UNITED STATES PATENT AND TRADEMARK OFFICE

APPLICATION NO.	FILING DATE	FIRST NAMED INVENTOR	ATTORNEY DOCKET NO.	CONFIRMATION NO.
10/632,758	08/01/2003	Akram Ali	706513US1	4650

Office Action Summary	Application No. 10/632,758	Applicant(s) ALI ET AL.	
	Examiner Joseph D. Pape	Art Unit 3612

DETAILED ACTION

FIG. 1

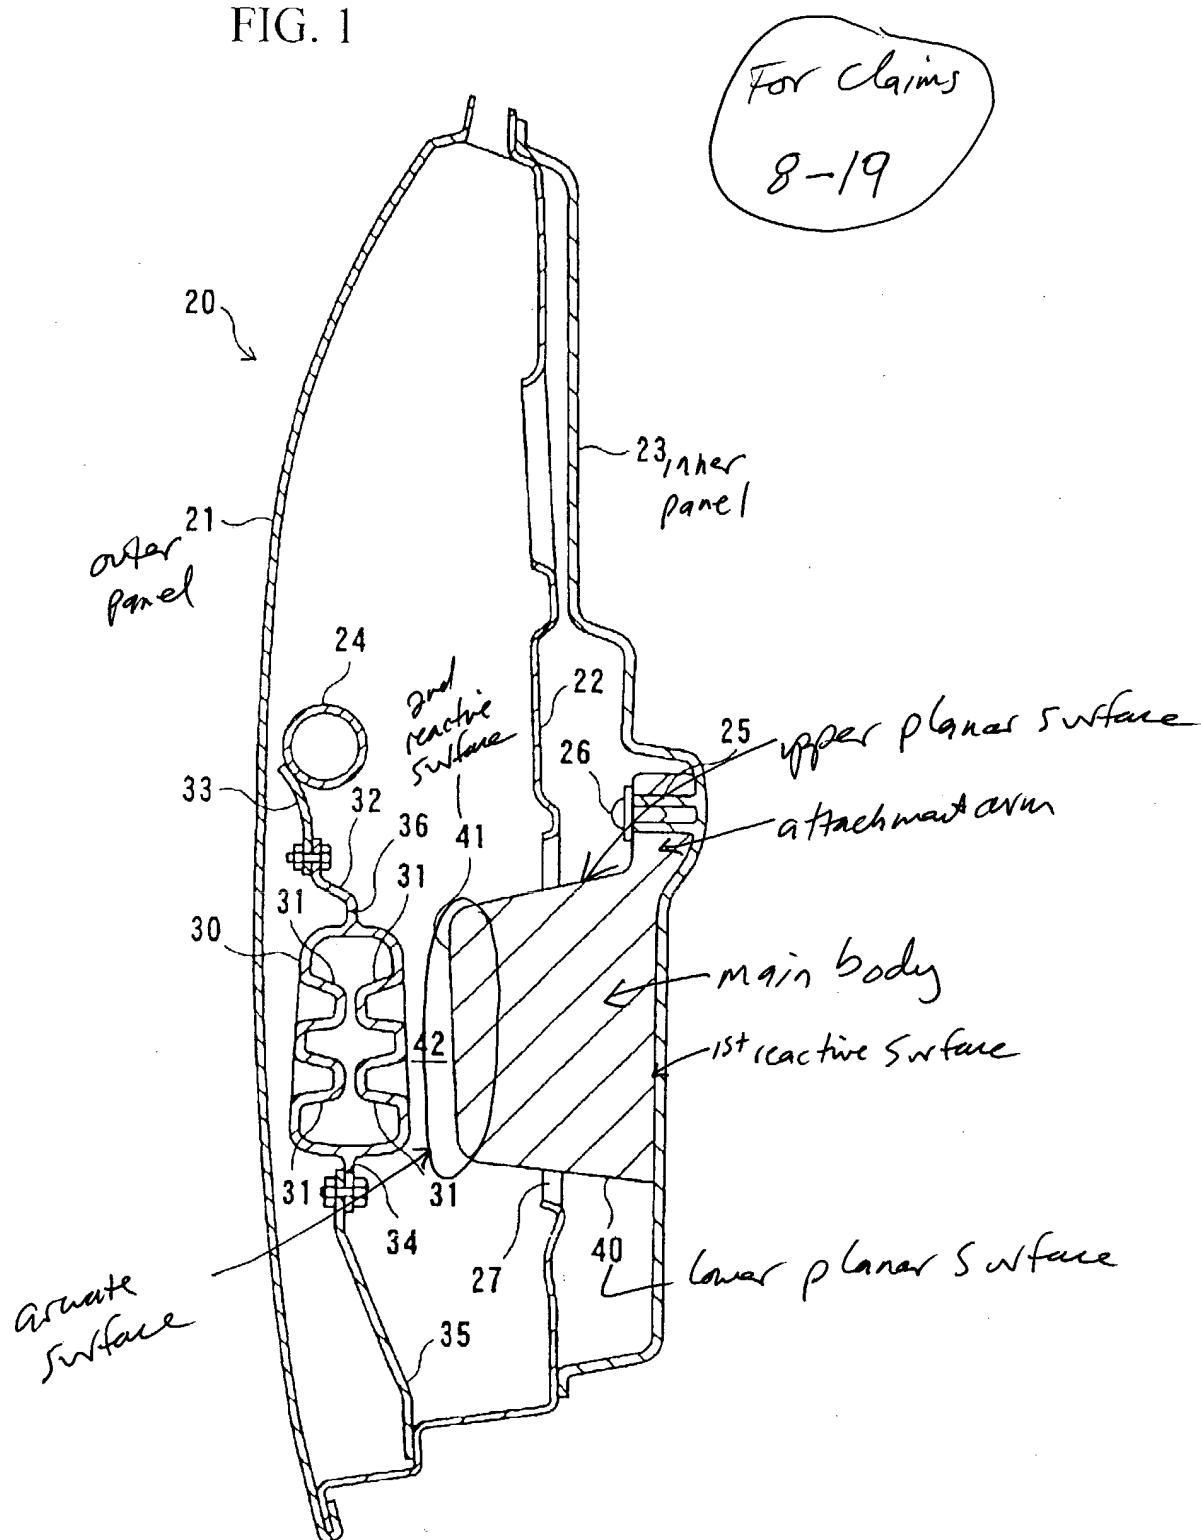
5. Claims 1-17, as understood, are rejected under 35 U.S.C. 102(e) as being anticipated by Fukutomi.

Fukutomi discloses the claimed invention as shown in the marked up copies of Figure 1 attached hereto. Note that there is one marked up copy for claims 1-7 and one marked up copy for claims 8-14. Regarding claims 7 and 14, the main body is considered to be relatively rigid in that it is described in column 3, lines

50-54 as compressing and deforming another element, thus being rigid at least relative to this other element. Regarding claim 15, Fukutomi is considered to inherently include structural members for supporting the door in an aperture in the vehicle as is the standard configuration for every vehicle mounted door.
